# MADRAS ELEMENTARY SCHOOL AND BUFF ELEMENTARY SCHOOL IMPROVEMENTS

PROJECT NO.: 22140B

## ADDENDUM NO. 1

DATE: September 20, 2023

Sheet No. **A2.14**

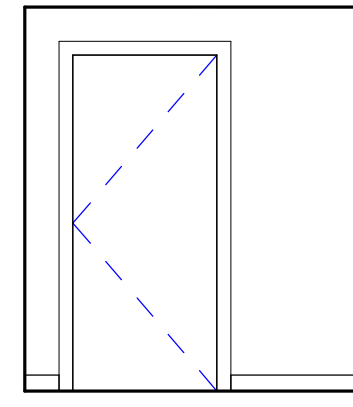
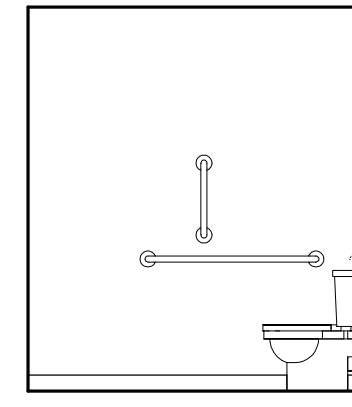
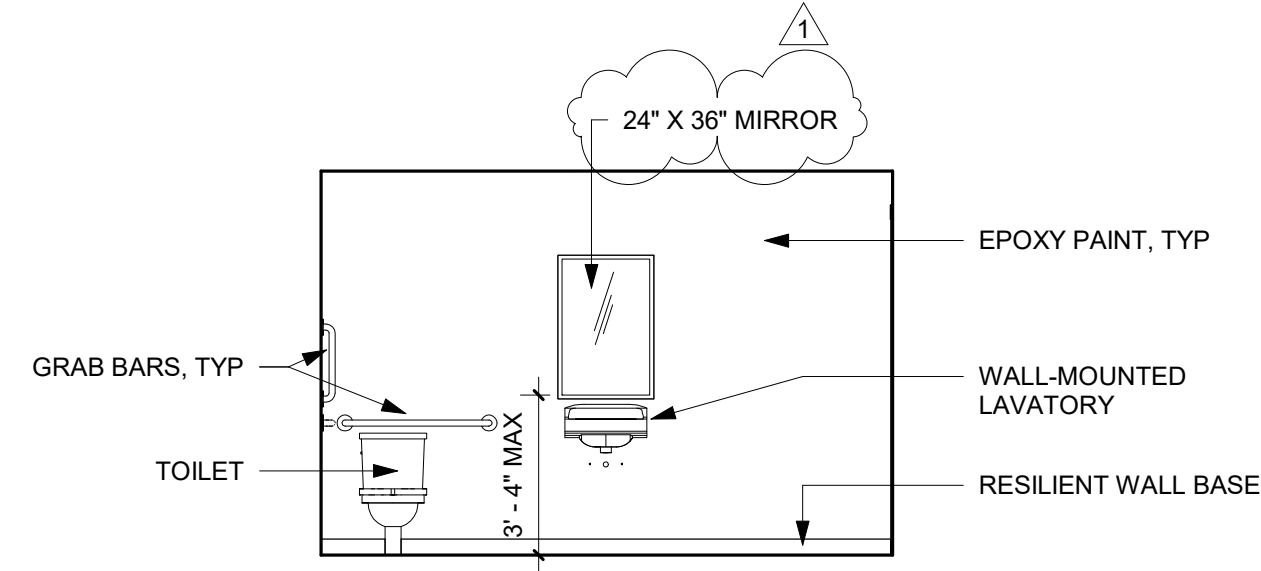
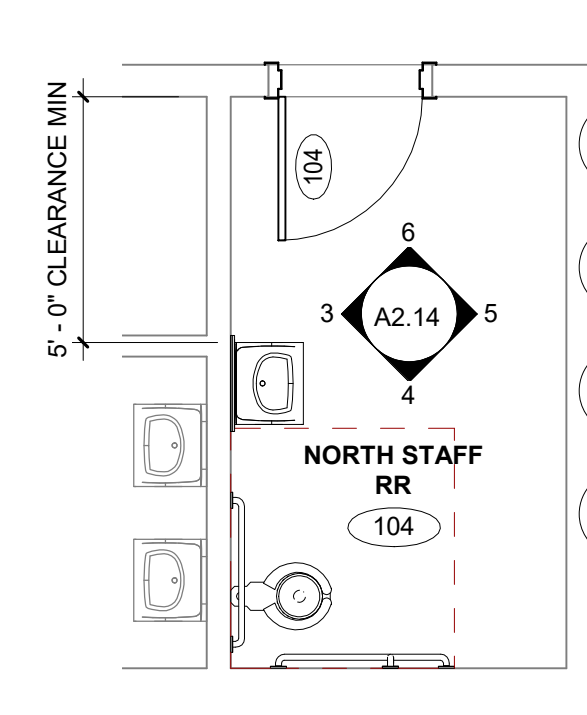
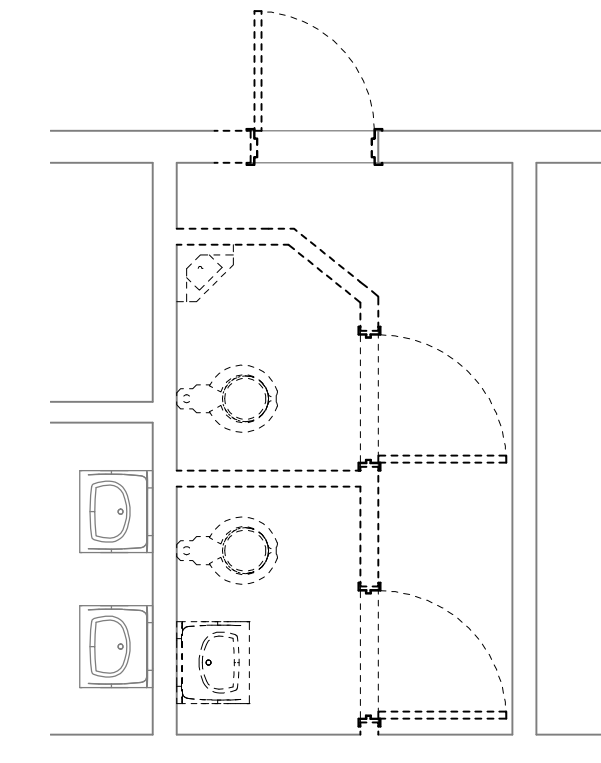
1. A2.14 Accessible Single-use Restroom-North
  - a. 1/A2.14: Added restroom accessory notes
  - b. 3/A2.14: Added mirror dimensions
2. A2.15 SPED Restroom
  - a. 10/A2.15: Added restroom accessory notes
  - b. 12/A2.15: Added mirror dimensions
3. A2.16 North Boys and Girls Restrooms
  - a. 10/A2.16: Added restroom accessory notes
  - b. 15/A2.16: Added mirror dimensions
4. A2.17 Accessible Single-use Restroom-South
  - a. 6/A2.17: Added restroom accessory notes
  - b. 10/A2.17: Added mirror dimensions

- RESTROOM ACCESSORY NOTE:**  
 INSTALL THE FOLLOWING ACCESSORIES IN THIS RESTROOM; SEE SPECIFICATIONS FOR PRODUCT INFORMATION; SEE SHEET AC0.03 FOR MOUNTING REQUIREMENTS.
- TOILET TISSUE DISPENSER; OFCI
  - PAPER TOWEL DISPENSER; OFCI
  - LIQUID SOAP DISPENSER; OFCI
  - GRAB BARS; CFCJ
  - SEAT COVER DISPENSER; OFCI
  - MIRROR; CFCJ
  - SANITARY NAPKIN DISPENSER; OFCI
  - RECESSED SANITARY NAPKIN DISPOSAL UNIT; OFCI
